PRODUCT CHANGE NOTICE

PCN#24-048**NOTIFICATION DATE: August 21, 2024****MODELS AFFECTED****SYDC-20-22HP+****EXTENT OF CHANGE:**

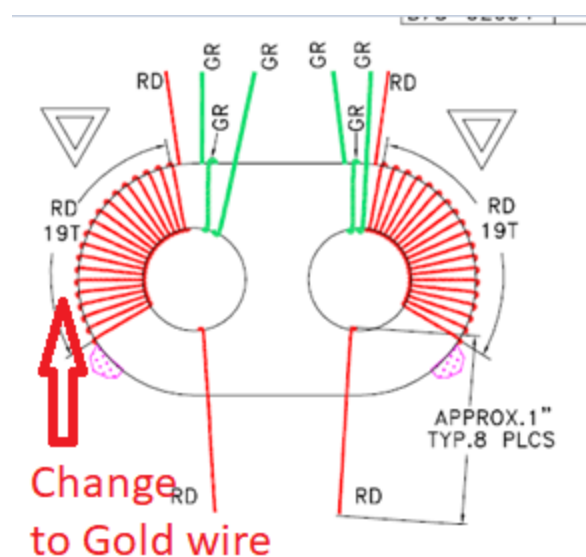
Wire color change on reverse winding side from red to gold

**EFFECT OF CHANGE:**No change to **FUNCTION** (Performance), or **FIT** (Dimension).Change to **FORM** (Appearance).**REASON FOR CHANGE:**

Immediate, either version may be shipped based on stock availability
